## SITE PLAN REVIEW AND APPEARANCE BOARD

### Bricktop's Restaurant

Meeting	File No.	Application Type
July 24, 2024	2022-300	Level 2- Site Plan Application
Property Owner	Agent	
12 NE 5 <sup>th</sup> LLC	Jeffrey A. Costello, AICP, FRA-RA

Consideration of a Level 2 Site Plan, Landscape Plan, and Architectural Elevations for the construction of a one-story, 4,420 sf restaurant with 580 sf mezzanine located at 12 NE 5<sup>th</sup> Avenue.

EAST ELEVATION

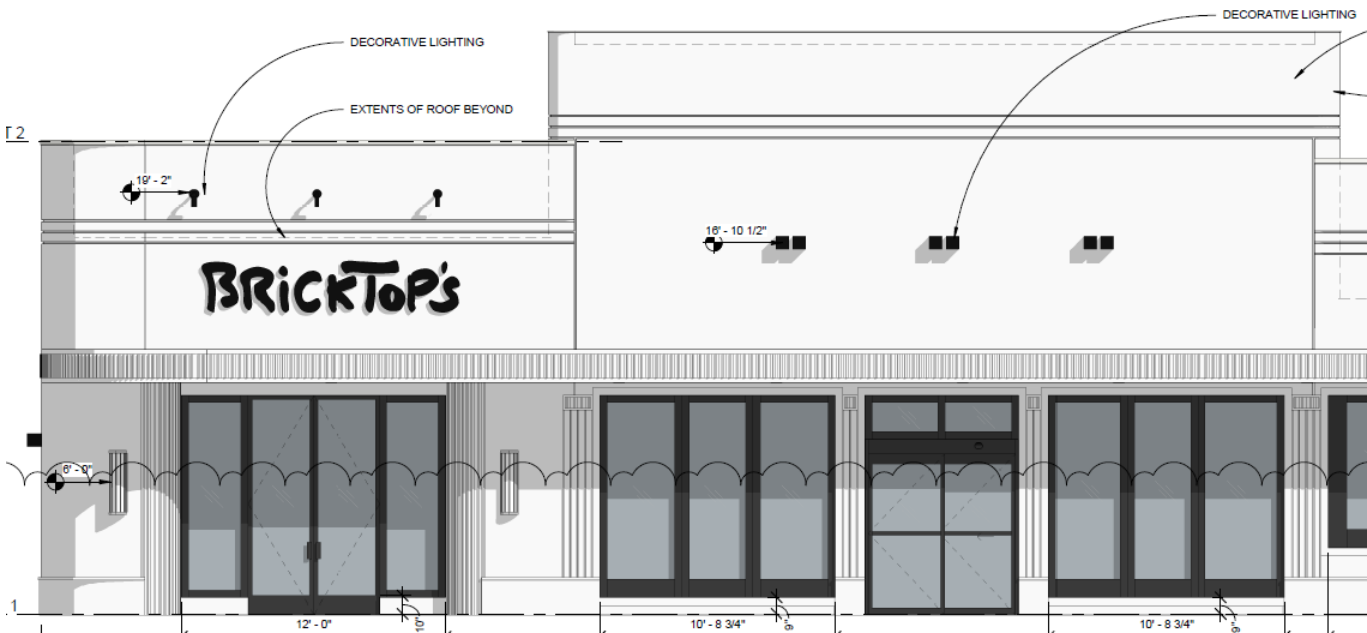
The East Elevation effectively maintains symmetries in the articulation of solid and void, but the other three elevations lack symmetry, massing, and richness of details. To better align with Art Deco principles, the designer should incorporate more pronounced elements, openings, and a mixture of colors, such as mirrored motifs or recurring patterns, to enhance visual cohesion and evoke the grandeur typically associated with this iconic style. To generate a more pleasant visual harmony and symmetry, additional effort in creating an iconic roof skyline is encouraged by emphasizing on the main entrance to be centered to create symmetry and accentuate the horizontal elements or capturing the corner with a vertical decorative tower used to display the name. Further enhancements towards detail depicting the local flora and fauna to be incorporated into the stucco and painted with contrasting colors.
